Illinois Tollway Base Sheet Revisions

Section M		Base Sheet Drawings	
Drawing	Modification Summary	Effective: 03-01-2026	
Roadway (RDY) - Series 400			
M-RDY-403	ROADWAY TYPICAL SECTIONS - GROUP D

PRECAST BRIDGE APPROACH SLAB LAYOUT

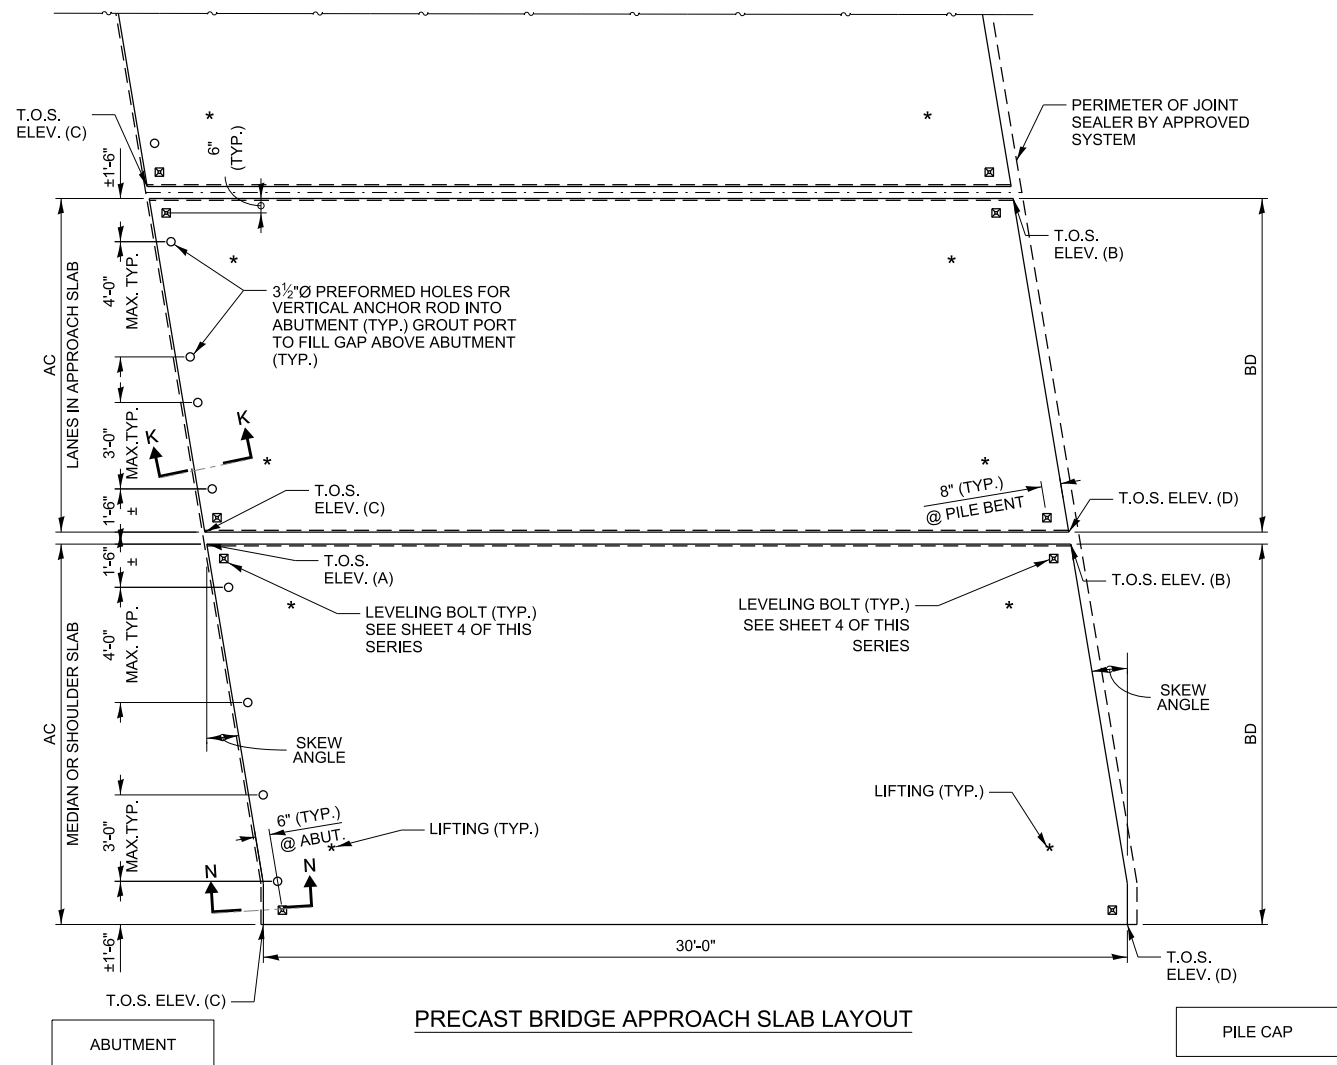
Sheet 1	Note 2 is revised to refer the latest updates from 'IDOT Bridge Manual' (2025)		
Sheet 2	Deleted anchor rod holes at pile cap in 'Precast Bridge Approach Slab Layout'.

**SECTION A-A
PRECAST BRIDGE APPROACH SLAB**

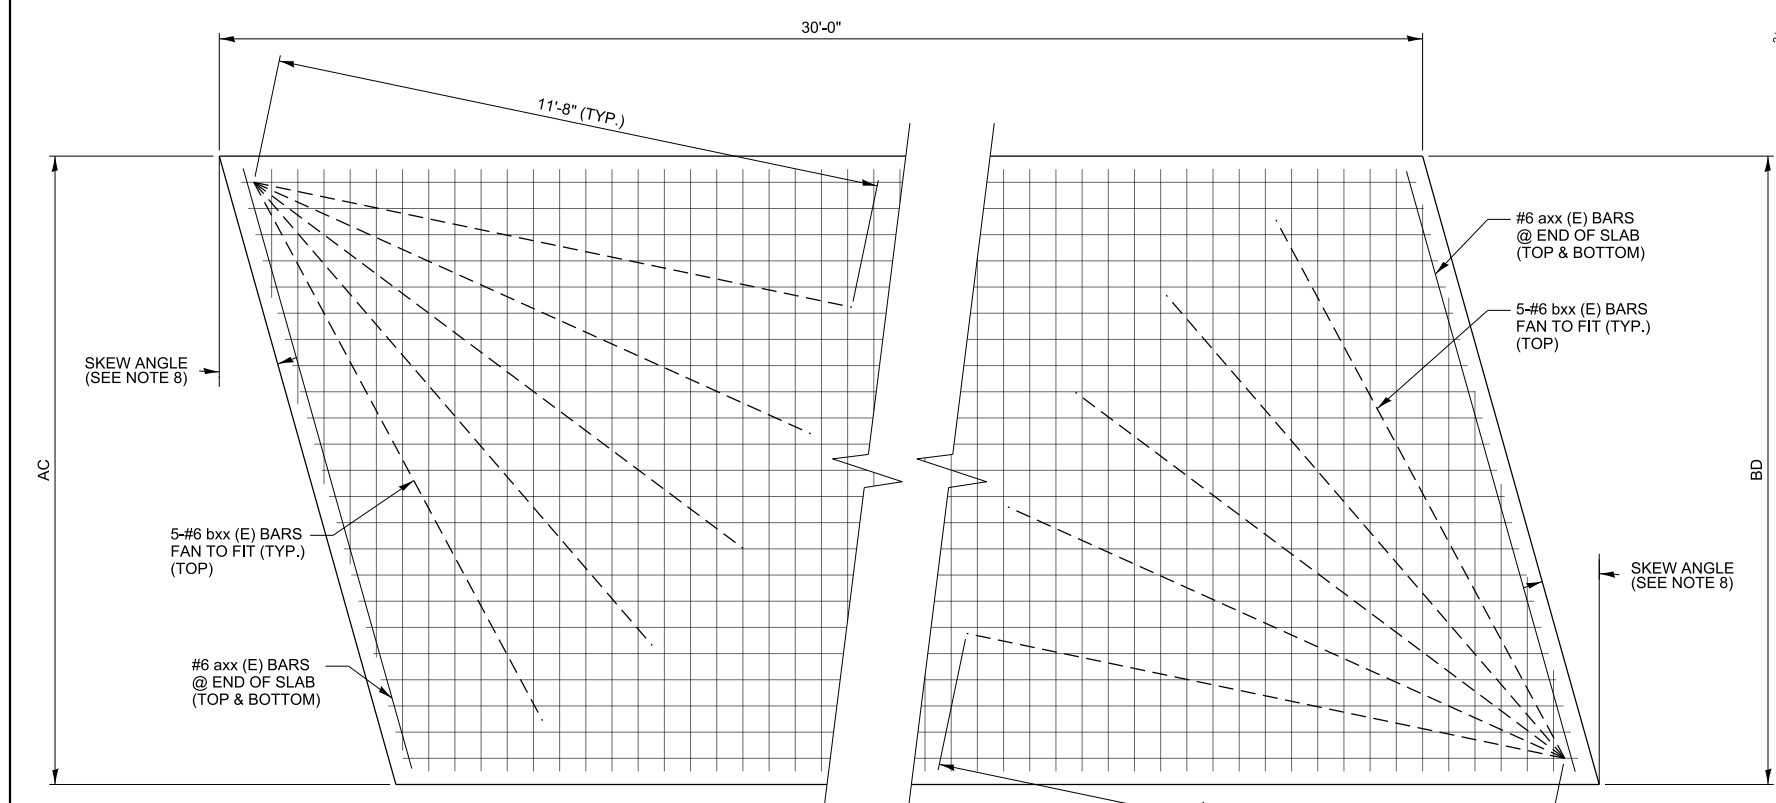
Sheet 3	Deleted 'Porous Granular Backfill' in the 'Longitudinal Cross Section' detail.		
	Added rebars at closure pours in 'Section A-A'.		
Sheet 4	Updated bar list table.

**EMERGENCY TURNAROUND
MEDIAN WIDTH ≥ 35 FT**

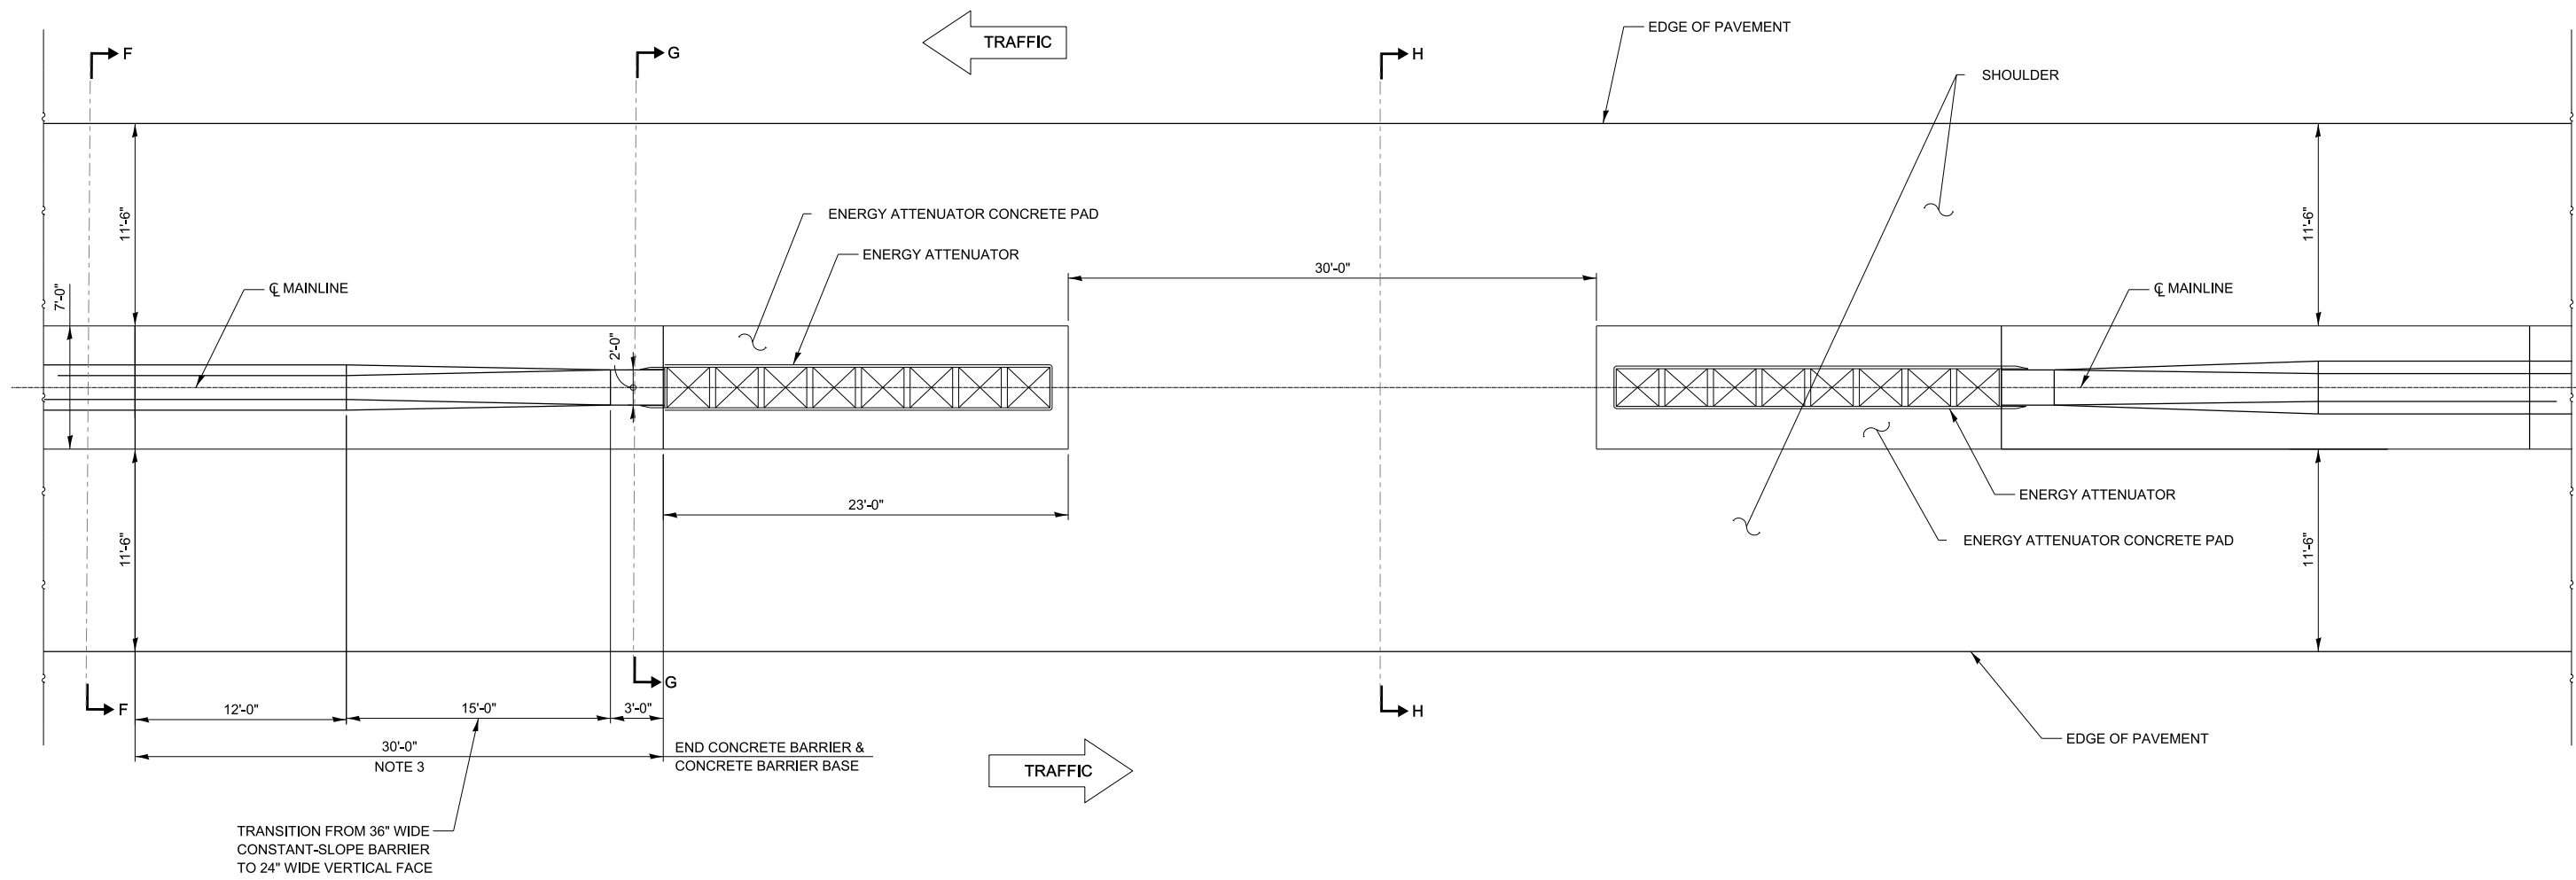
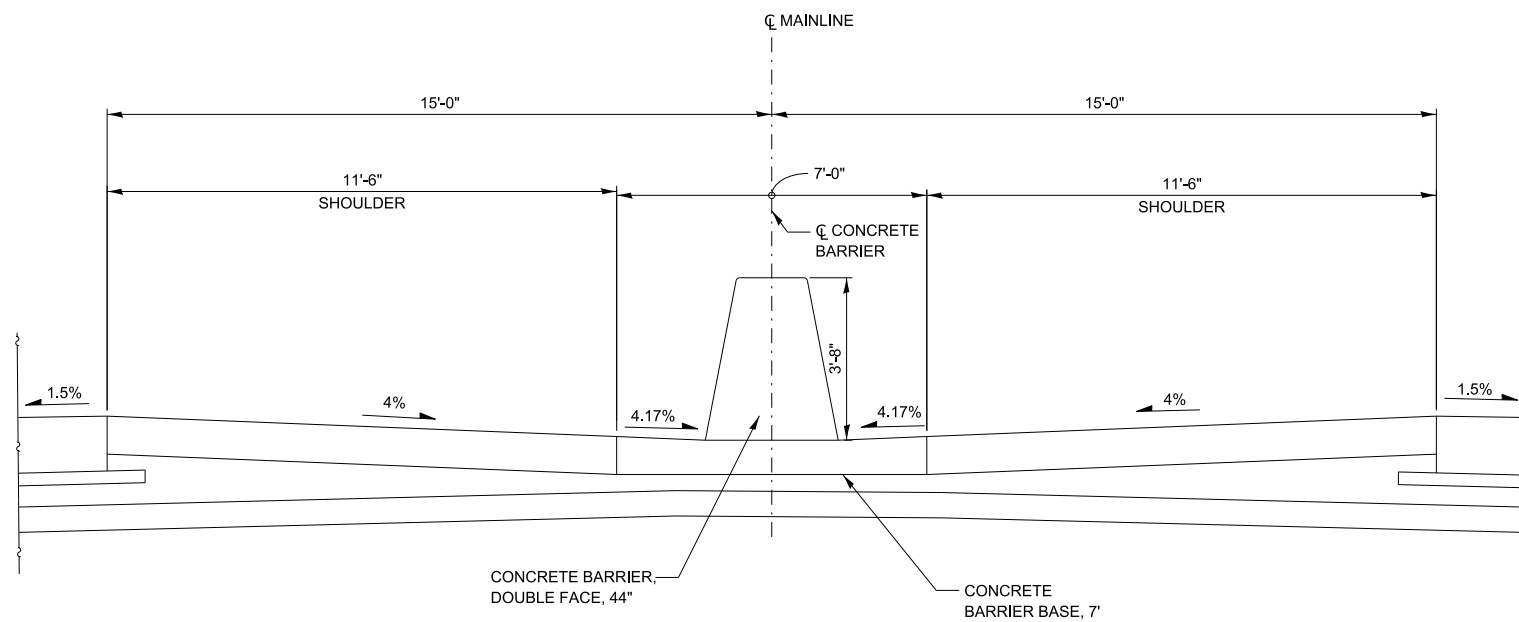
Sheet 1	Updated 'Concrete Barrier' & 'Base' taper rate call out for a clarification		
M-RDY-418	RAMP TOLL PLAZA PAVEMENT DETAILS		
Sheet 1	Revised 'Ramp Toll Plaza Roadway Details for Rehabilitation Projects' detail for a single face concrete barrier taper on the upstream end to comply with the Traffic Barrier Guidelines (TBG) Article 13.2.1 requirements. Additionally provided 'Note to Designer' to state TBG Article 13.2.1.		
	Added '...and must extend at least 1 foot beyond an existing transverse contraction joint' to 'Note to Designer' for 'Proposed JPCP Improvement Limit...'

1. SEE SHEET 4 OF THIS SERIES FOR SECTIONS F-F THROUGH H-H.
2. THE TAPER SHOWN FOR THE CONCRETE BARRIER AND CONCRETE BARRIER BASE IS DUPLICATED FOR THE OPPOSING TRAFFIC DIRECTION.
3. CONCRETE BARRIER SHALL BE PINNED TO BARRIER BASE BY PAIRS OF 12" TIE BARS AT 30" CENTERS IN THE LAST 30' OF THE CONCRETE BARRIER.
